266 West Concord
MEETING NOTES 07/26/13

266 Concord St West, Louise McCarthy 767-0642 *(000 Building.JPG)*
Pre inspection to legalize one existing no conforming unit to be a total of three units.

A-1.1

266 West Concord Street
Portland

Second Floor Existing Plan (demolished, unoccupied)

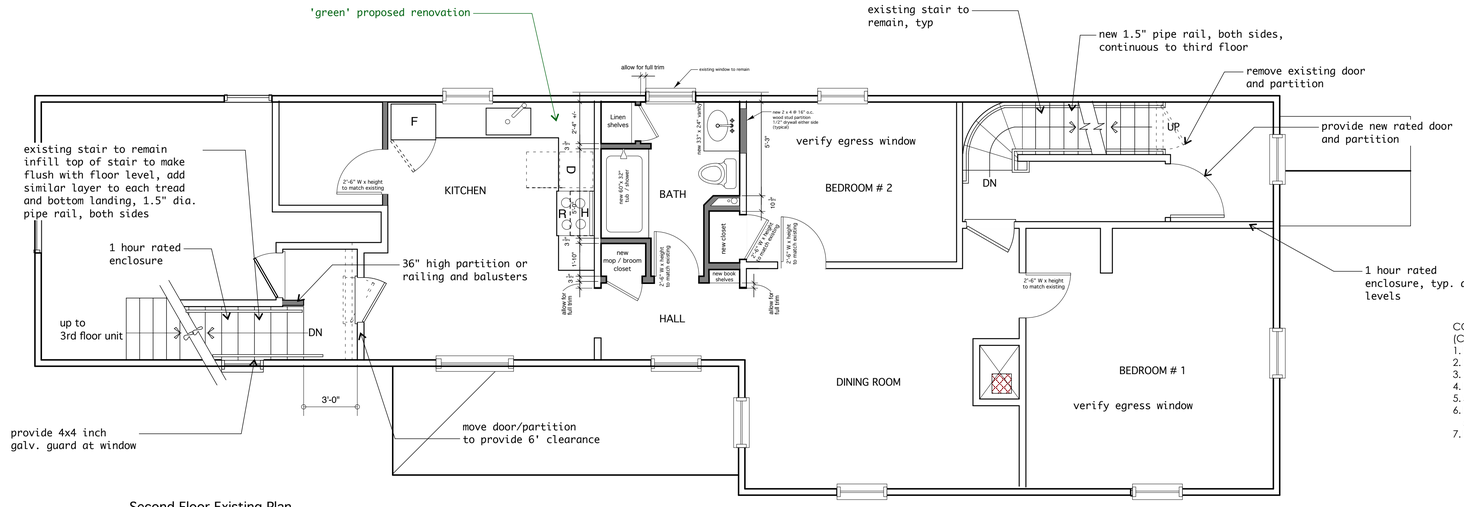
CODE ISSUES:
(CURRENTLY DEMOLISHED)
1. EGRESS WINDOWS.
2. REAR STAIR UPGRADE.
3. 3RD FLOOR FRAMING.
4. RATED CEILING.
5. STC RATING CEILING.
6. RATING BETWEEN BACK ROOM AND DEMO'D APARTMENT AND FRONT STAIR.
7. FIRE BLOCKING BETWEEN UNIT ABOVE AND UNIT BELOW.

1. verify framing load capacity of 3rd floor framing.
2. provide fire stops between 1st and second floor and 2nd and 3rd floor.
3. 2nd floor ceiling to be 1 hour rated, insulated to meet stc rating 50 min and IIc rating 50 min.
4. all doors to egress stairs to be 20 min rated.
5. fire blocking between unit above and unit below.

Third Floor Existing Plan

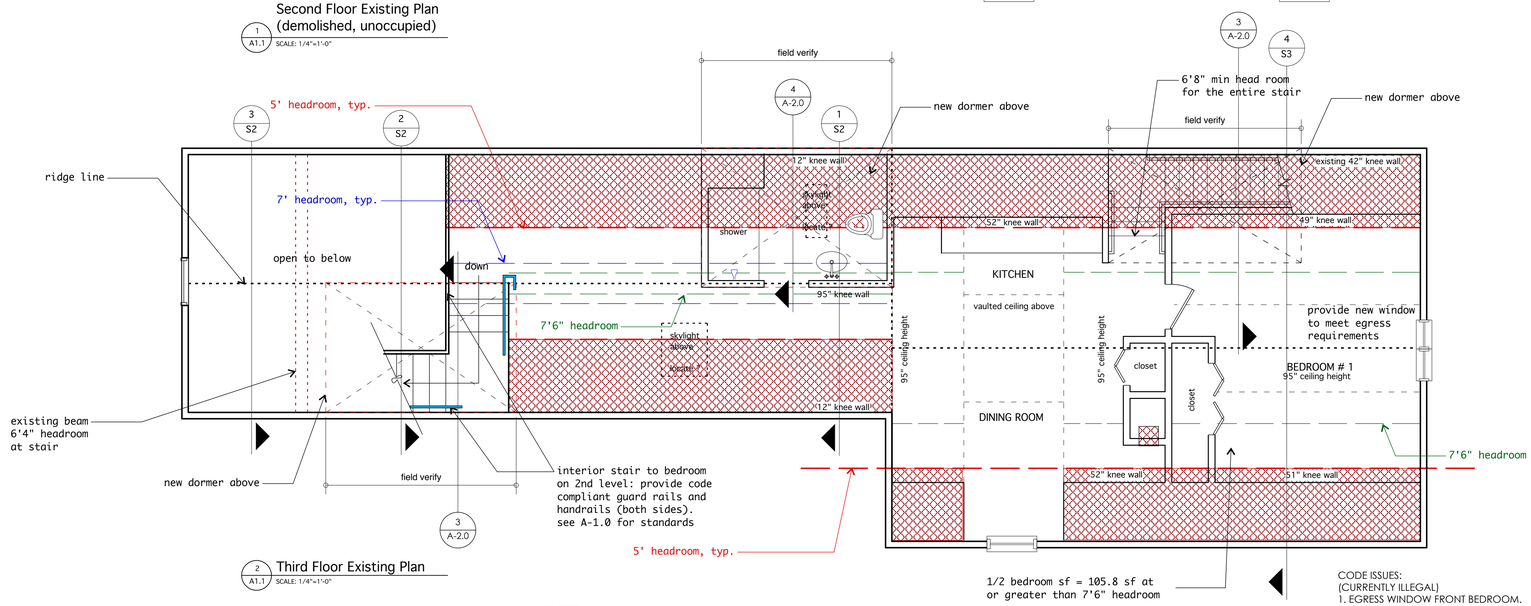
CODE ISSUES:
(CURRENTLY ILLEGAL)
1. EGRESS WINDOW FRONT BEDROOM.
2. FRONT STAIR NTC. HEADROOM, RAILINGS, T+R DIMENSIONS.
3. REAR STAIR CONFIGURATION, HEADROOM, HANDRAILS, T+R DIMENSIONS.
4. 3RD FLOOR FRAMING ASSUMED NTC.
